# SERVICE BULLETIN

Classification: EC01-011a	Reference: NTB01-036a	Date: September 17, 2001
------------------------------	--------------------------	-----------------------------

## MIL "ON" WITH DTC P0100 (MASS AIRFLOW SENSOR – MAFS) STORED

**IMPORTANT: THIS BULLETIN HAS BEEN AMENDED**

Figure 1

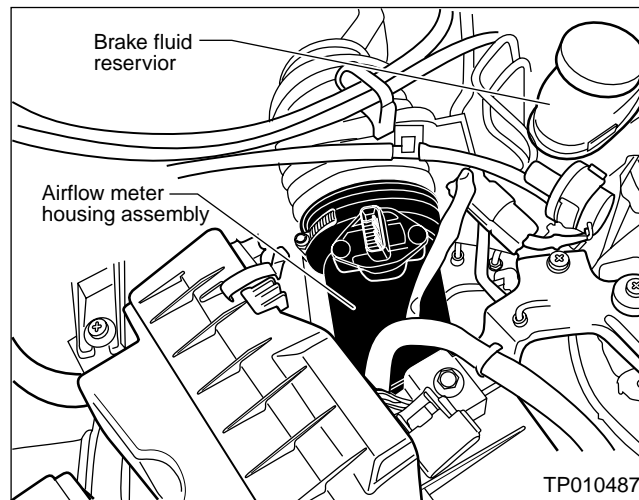
2. Install a new genuine Nissan replacement air filter element into the filter housing cover, then install this assembly in the air filter housing.
3. Install the new complete airflow meter assembly (see Figure 1). Refer to the Parts Information table for the new airflow meter assembly part number.

- The new airflow meter assembly **MUST** be installed as a complete unit
- Do not attempt to transfer the new airflow sensing element to the old airflow meter housing. The new element is not compatible to operate in the old housing and will cause performance and emissions to be impaired.
